STATE OF NORTH CAROLINA
DEPARTMENT OF TRANSPORTATION

July 9, 2004

SUBJECT: Permit Modification Request for TIP No. U-2527, Vance County, Western Outer Loop from SR 1128 (Ruin Creek Road) to SR 1101 (Old County Home Road) near Henderson, Federal Aid No. STP-0509(2), State Project No. 8.2390201, NCDOT Division 5, \$475 Debit WBS Element 34822.1.1.

The purpose of this letter is to request modifications to the CWA Section 404 Individual Permit issued by the USACE, the 401 Water Quality Certification issued by the NC Division of Water Quality (DWQ), and Riparian Buffer Certification issued by DWQ. Revised permit drawings are attached. A revised natural stream design plan is also attached.

BUFFER IMPACTS
SITE 8
PLAN VIEW

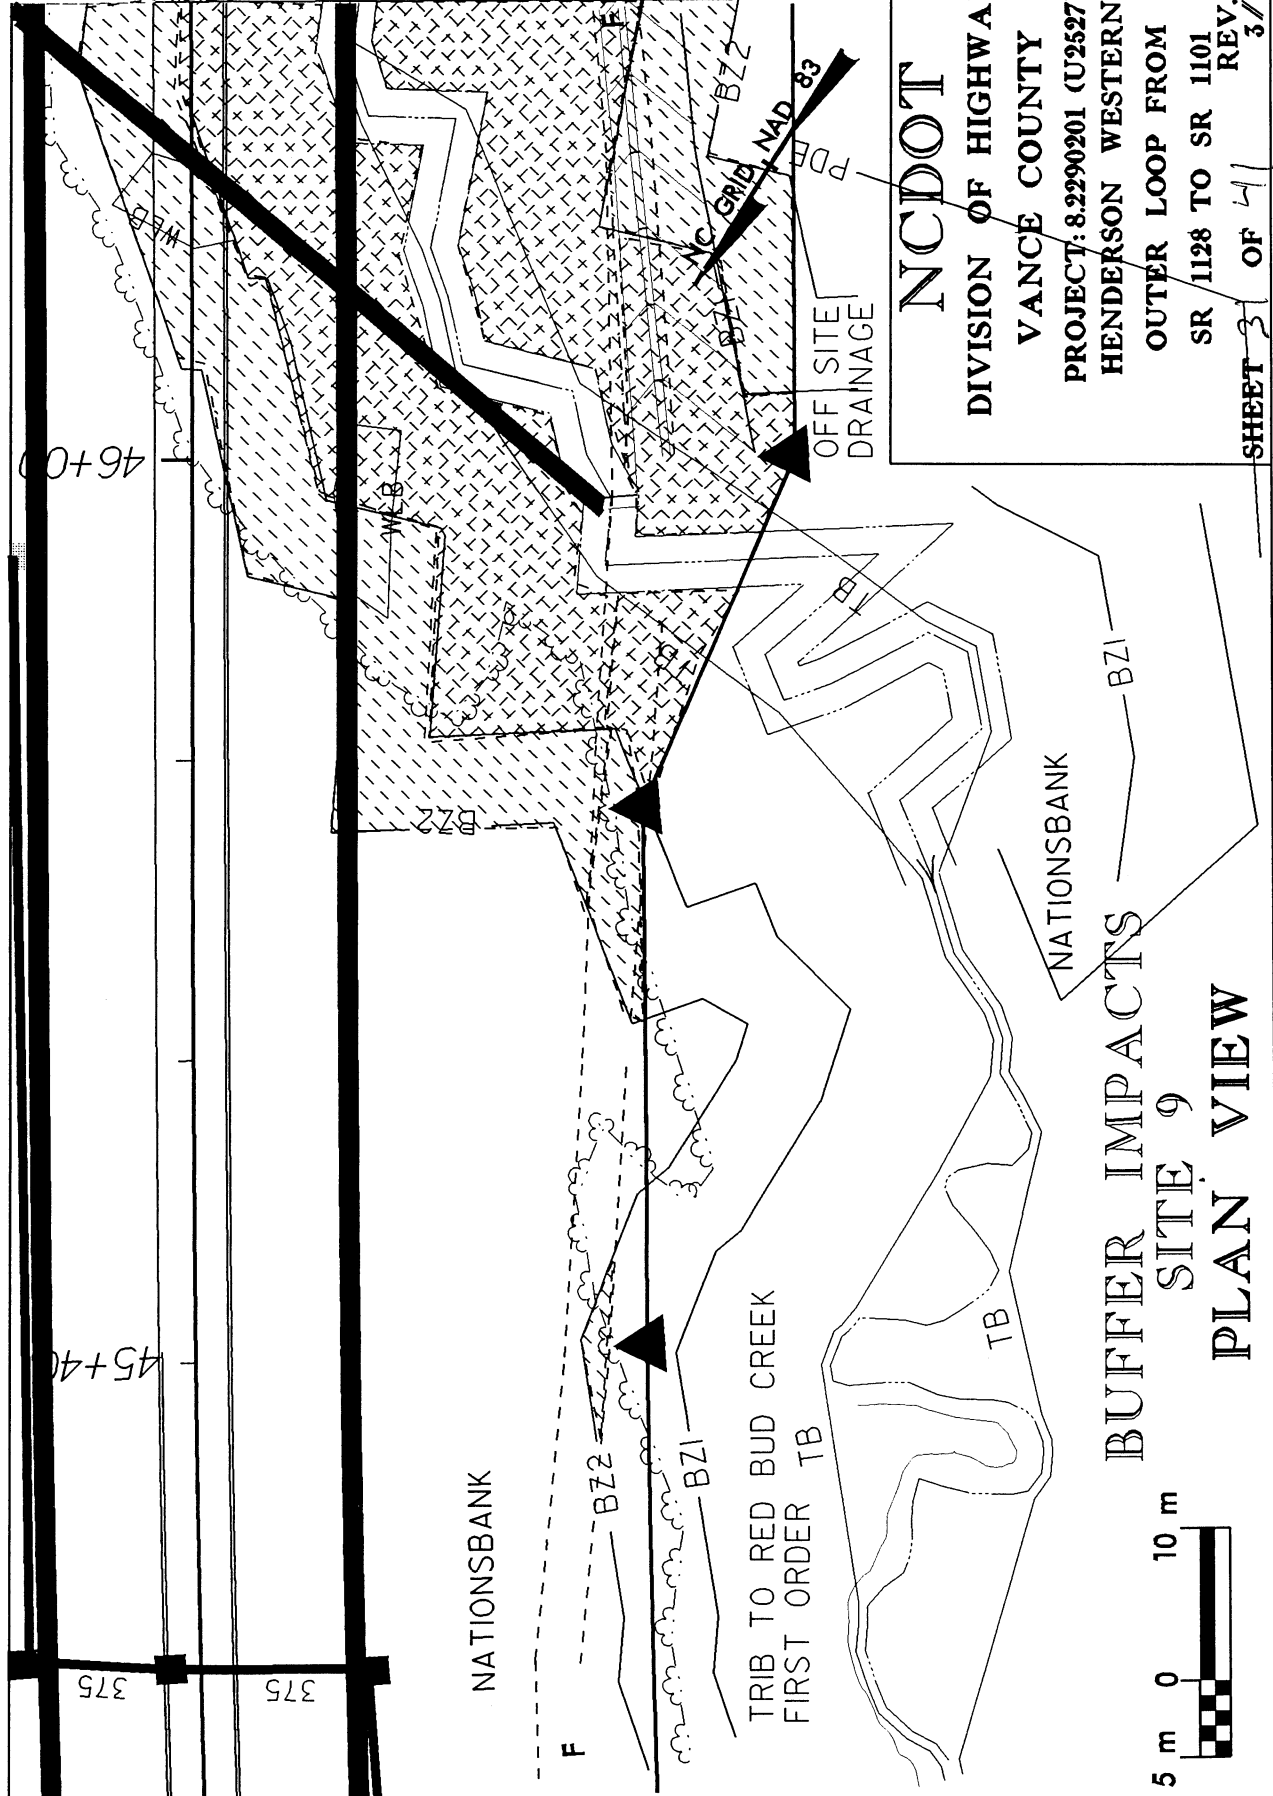
- Stream site 6, buffer site 8 (permit drawing 11 and 30, plan sheet 12, erosion control sheet EC-13, Station 40+81)

Issue: The plan sheet depicts Structure 92 at Station 40+39 Rt and Structure 93 at Station 40+59 Rt. These structures are not depicted on the permit drawing.

Issue: The plan sheet depicts a Preformed Scour Hole (PSH) located outside of the riparian buffer at Station 40+90 Rt. This PSH is located inside of the riparian buffer on the permit drawing.

Issue: The tie in points of the temporary channel change as depicted on EC-13 are located outside of the permitted stream and buffer footprint as depicted on the permit drawing.

Issue: There are slight discrepancies in the depiction of the fill slopes in the northeast, northwest and southwest quadrants between the permit drawing and the plan sheet.

Issue: The plan sheet indicates the presence of rip rap at the inlet and outlet of the structure. The impact associated with the rip rap is not entirely depicted as buffer impacts on the permit drawing.

Status: The permit drawing has been modified to depict structures, the correct location of the PSH, revised stream impact, revised buffer impact, additional buffer impact and the correct fill slope. **This resulted in an increase of stream impact of 9.9 ft.**

BUFFER IMPACTS
SITE 9
PLAN VIEW

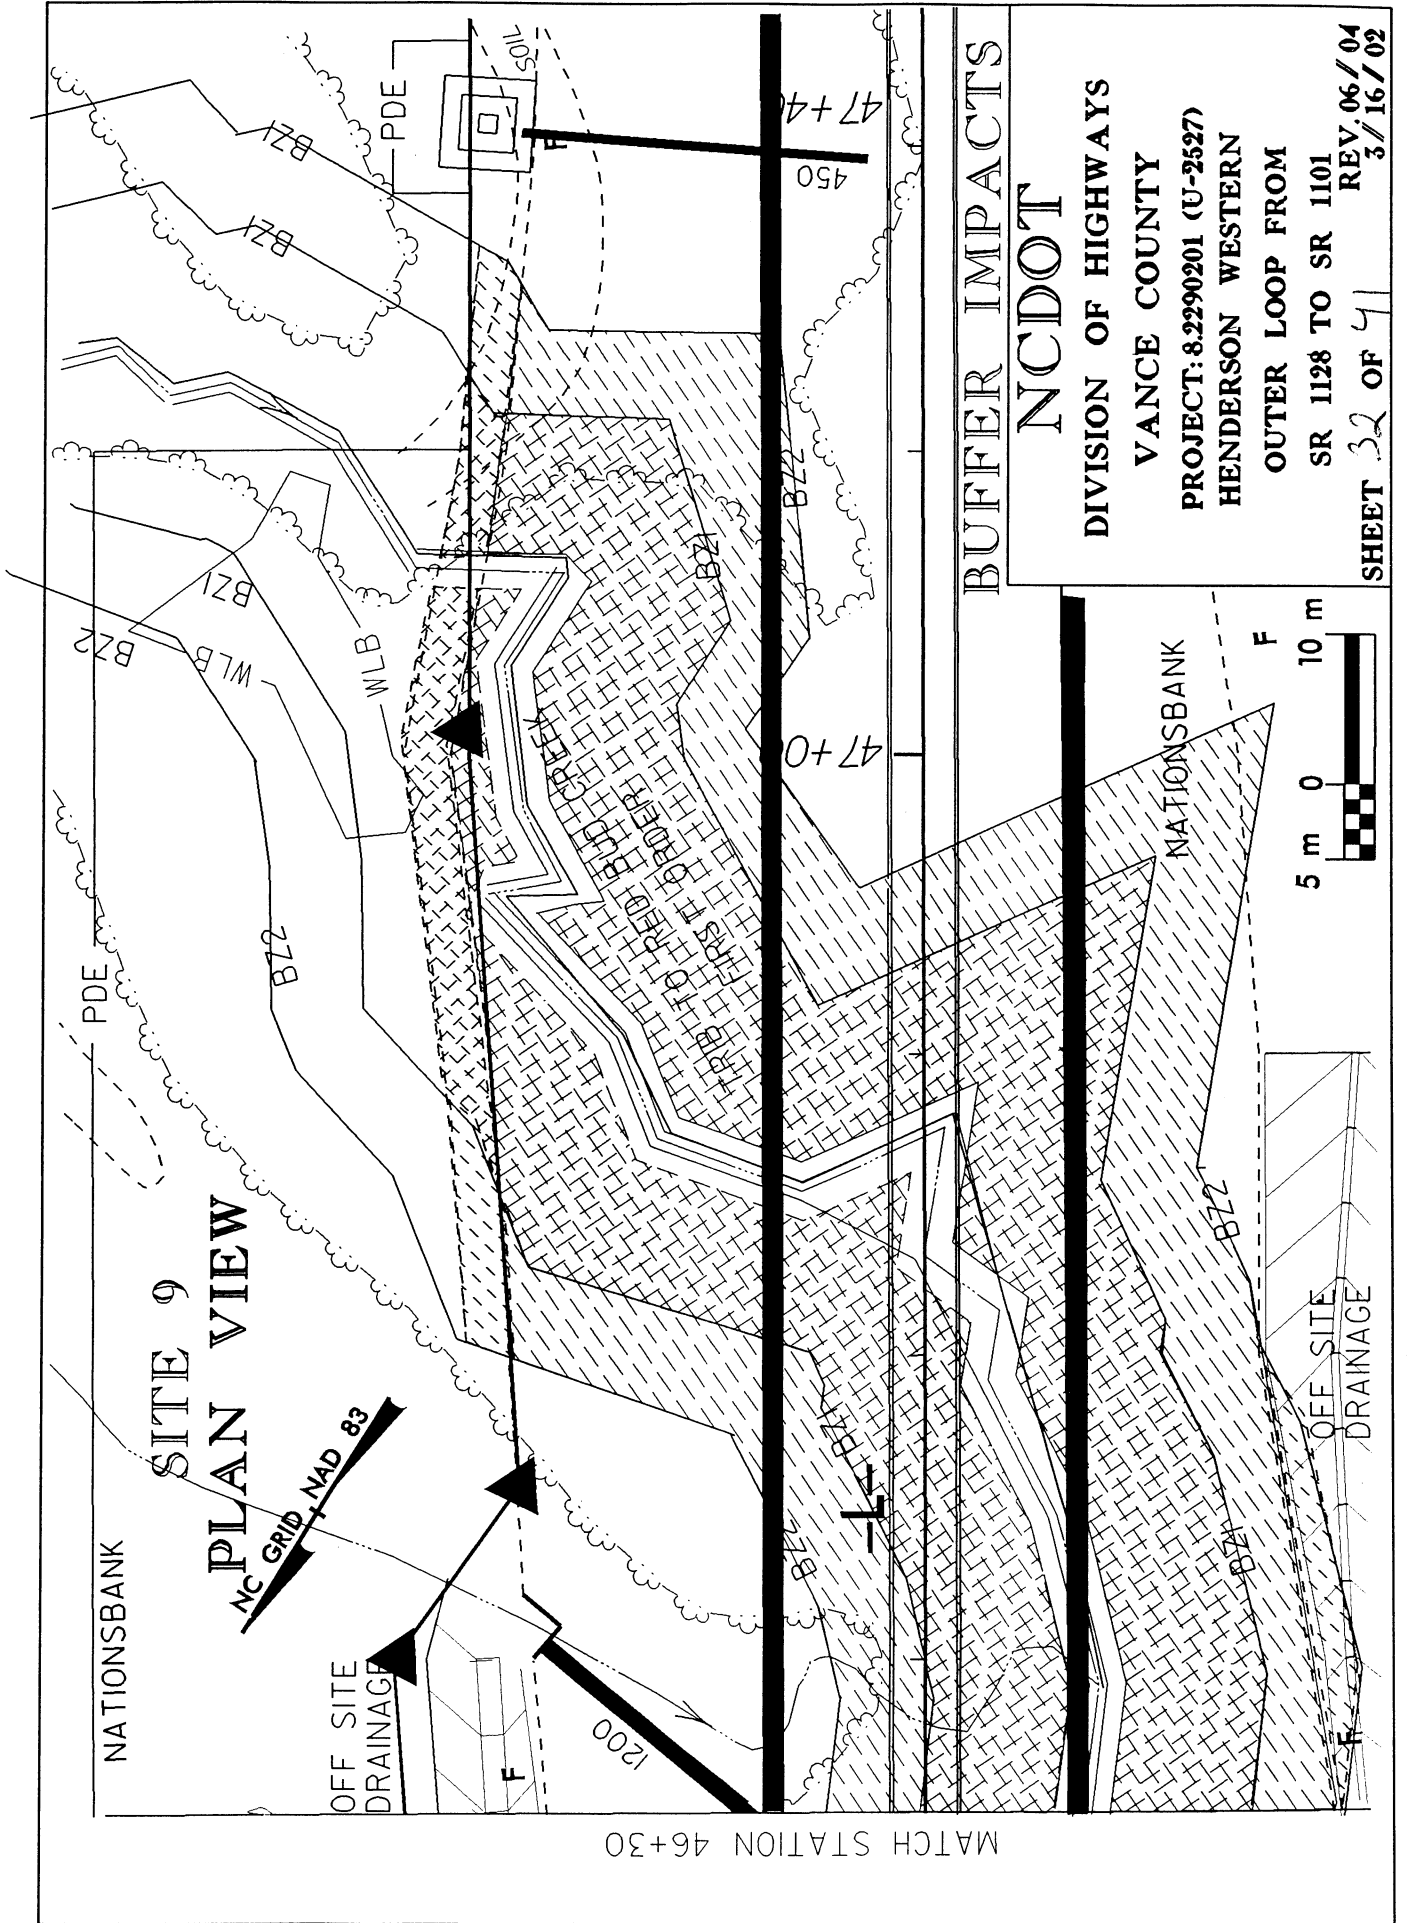
- Stream site 7, buffer site 9 (permit drawing 12, 13, 31, and 32, plan sheet 14, Station 46+20)
Issue: The plan sheet depicts a lateral base ditch through the riparian buffer at Station 46+10 Rt. This lateral base ditch is not depicted on the permit drawing.
Issue: The plan sheet depicts a lateral base ditch at Station 46+30 Lt. This lateral base ditch is not depicted on the permit drawing.
Issue: The plan sheet depicts a 450mm cross pipe and an associated PSH at Station 47+40. The cross pipe and PSH are not depicted on the permit drawing.
Issue: The plan sheet depicts a small portion of the riparian buffer within the mechanized clearing limits of the project at Station 45+40 Rt. This buffer impact is not depicted on the permit drawing.
Status: The permit drawing has been modified to depict the lateral base ditches, cross pipe, additional buffer impact and PSH. **This resulted in an increase of riparian buffer impact of 0.03 ac (1306.8 square ft) in Zone 1 and 0.01 ac (435.6 square ft) in Zone 2.**
